ECE/TRANS/WP.29/2007/20/Rev.1  
31 July 2007

Proposal for the 04 series of amendments to Regulation No. 48  
(Installation of lighting and light-signalling devices)

Revised proposal for the 04 series of amendments to Regulation No. 48

Submitted by the representative of the European Community

Model A

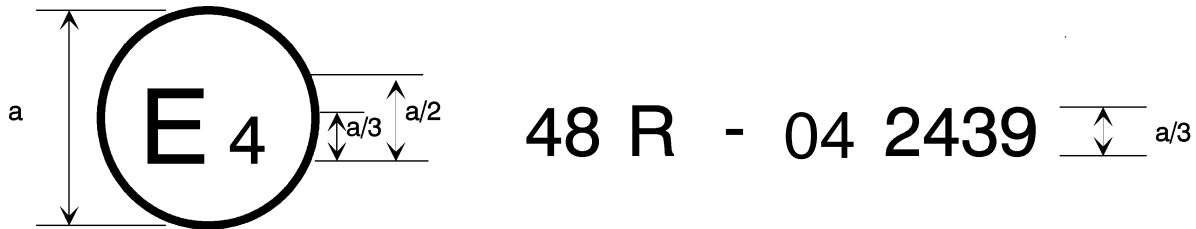
Annex 2, amend to read:

The above approval mark affixed to a vehicle shows that the vehicle type concerned has, with regard to the installation of lighting and light-signalling devices, been approved in the Netherlands (E4) pursuant to Regulation No. 48 as amended by the 04 series of amendments. The approval number indicates that the approval was granted in accordance with the requirements of Regulation No. 48 as amended by the 04 series of amendments.

Model B

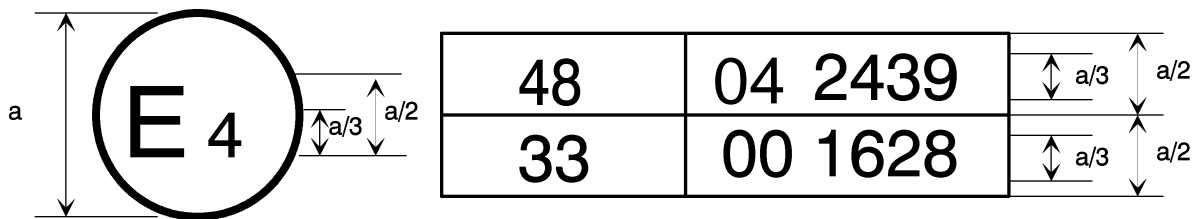
The above approval mark affixed to a vehicle shows that the vehicle type concerned has been approved in the Netherlands (E4) pursuant to Regulation No. 48 as amended by the 04 series of amendments and Regulation No. 33. 1/ The approval number indicates that, at the dates when the respective approvals were given, Regulation No. 48 was amended by the 04 series of amendments and Regulation No. 33 was still in its original form.
